GOLIAD COUNTY GROUNDWATER CONSERVATION DISTRICT

RE: Goliad County Groundwater Conservation District (GCGCD) comments on the new TWDB GAM for GMA-15 & 16.

RE: Comments on the Gulf Coast Aquifer System Groundwater Availability Model

COMMENTS ON THE GULF COAST AQUIFER SYSTEM GAM

Figure 1 – Modeled and Observed Water Levels in Observation Well 7913223 within Goliad County.

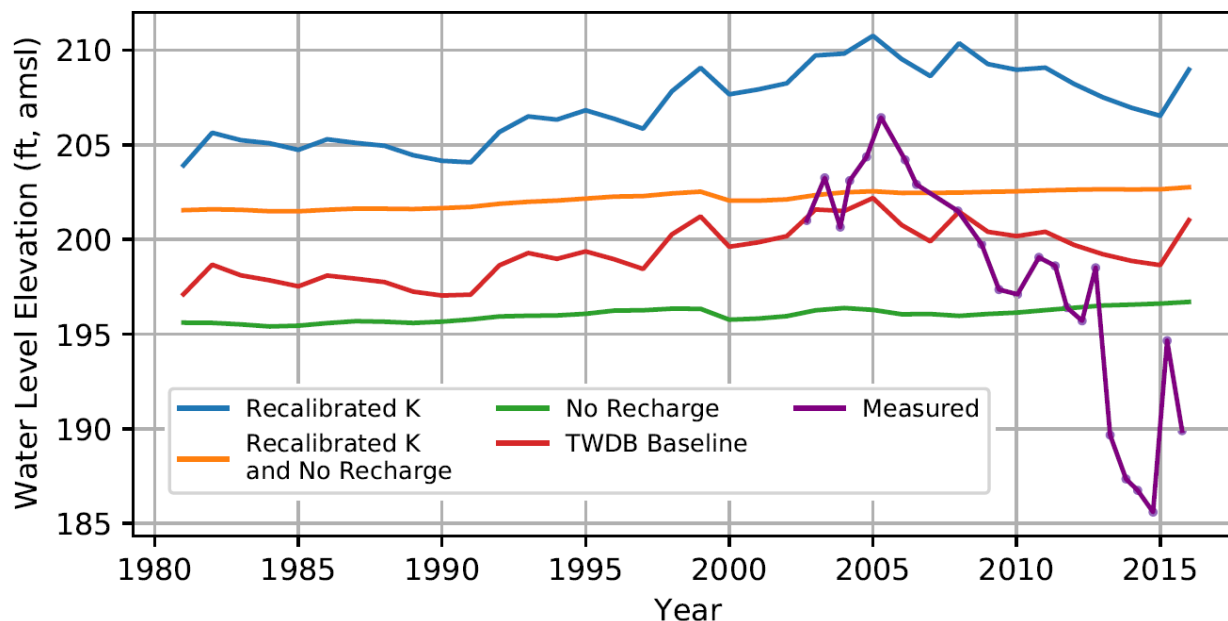
Figure 1 presents plots of modeled and observed water levels for well 7913223, located within Goliad County. The modeled water levels are computed at the center of the grid cell location containing the physical well 7913223; I did not interpolate water levels to the exact well location (as TWDB has reportedly done as documented in their draft report detailing the “New Model.”) I also did not adjust the modeled water levels to simulate drawdown expected from a pumping well, as TWDB did for this particular well. This topic will be discussed later.

As shown in Figure 1, there is an observed decrease in measured water levels, from approximately 201 ft MSL in 2003 to 190 ft MSL in 2016 with year-to-year fluctuations in between. Water levels modeled by the “New Model” (Shown in red as the “TWDB Baseline” results) suggest water level fluctuations over this time period, but do not indicate a decline in water levels. In fact, over the entire model period, the TWDB Baseline results suggest water levels range from 197 ft to 202 ft MSL, and show a generally increasing trend.

To assess the sensitivity of the modeled results to recharge and hydraulic conductivity values, I modified the New Model to incorporate changes that yielded improvement to the Old Model’s ability to reproduce GCGCD observed water levels. The modified New Model results are shown in Figure 1 as the “No Recharge,” “Recalibrated K,” and “Recalibrated K and No Recharge” results. These result sets indicate that by eliminating recharge, the modeled year-to-year annual water level fluctuations are greatly reduced, resulting in a much “flatter” time series. These flatter time-series datasets also indicate that water levels were generally increasing over the modeled period of record. Through changing the modeled hydraulic

Based on Figure 1, it is possible to imagine that better agreement between modeled and observed water levels for well 7913223 could be achieved through further fine-tuning of the hydraulic conductivity of the model cells adjacent to the well, perhaps along with refining the magnitude of the aquifer response to changes in annual recharge. Within Appendix A of their draft “New Model” report, TWDB indicated that it used data from this well when compiling its regional model statistics. I concluded that TWDB actually used modeled water levels (from the TWDB baseline model) and then modified them to simulate the effects of local drawdown due to well pumping. I was able to calculate the same water levels as TWDB published in Appendix A when I ran the model and applied TWDB’s simulated effects of local drawdown due to well pumping. However, I determined that well 7913223 is NOT a pumping well, and therefore TWDB incorrectly applied the well pumping adjustments to this well. As such, the agreement between the modeled and observed water levels at this location is artificially high within the TWDB New Model database. I do not know if TWDB made similar errors at other well locations listed within Appendix A, but this discovery with respect to well 7913223 does not provide confidence in TWDB’s overall model verification process.

Figure 2 - Modeled and Observed Water Levels in Observation Well 722903 within Goliad County.

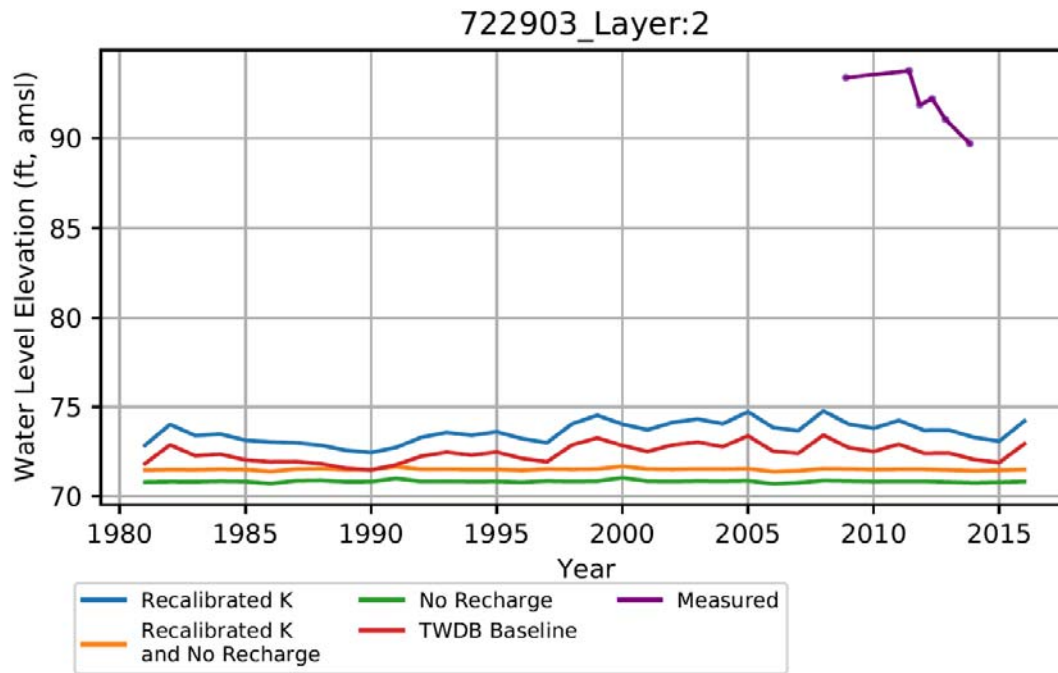
Other examples of the disagreement between modeled water levels and those obtained from wells within the GCGCD monitoring network are shown in subsequent images. Each graphic was selected to illustrate the various ways in which the modeled and observed water levels differed. For example, the observed water level in well 722903 is approximately 15 ft higher than the modeled water levels (Figure 2). In contrast, measured water levels for well 7913111 were about 25 ft below the modeled water levels (Figure 3). In both instances, a decreasing trend in observed water levels is evident.

Figure 4 - Modeled and Observed Water Levels in Observation Well 7905905 within Goliad County.

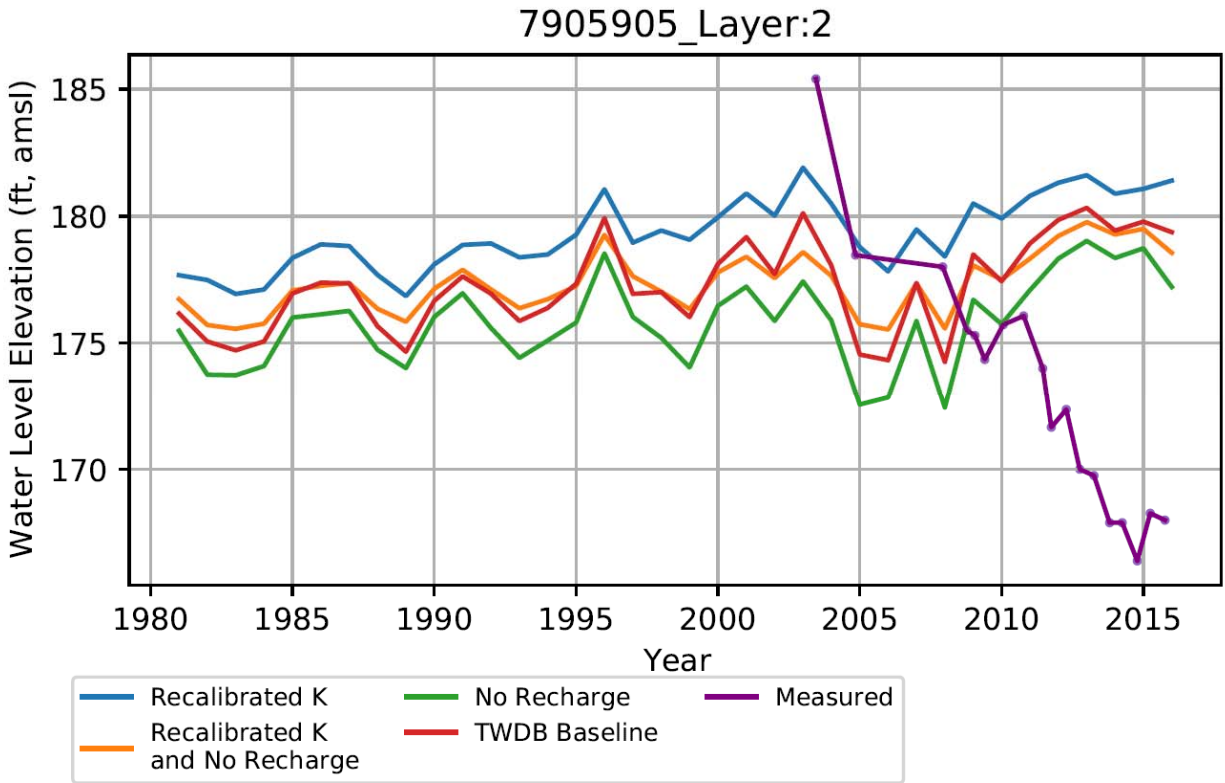
For well 7905905, the 2004 water level exceeded the TWDB Baseline water level by approximately 8 ft, but by 2016 observed water levels were about 10 ft below modeled water levels (Figure 4). For well 7905606, the magnitude and range of modeled water levels match the observed magnitude and range of the measured water level, yet modeled levels show an increasing trend whereas the observed water levels decreased from 2004 to 2016 (Figure 5).
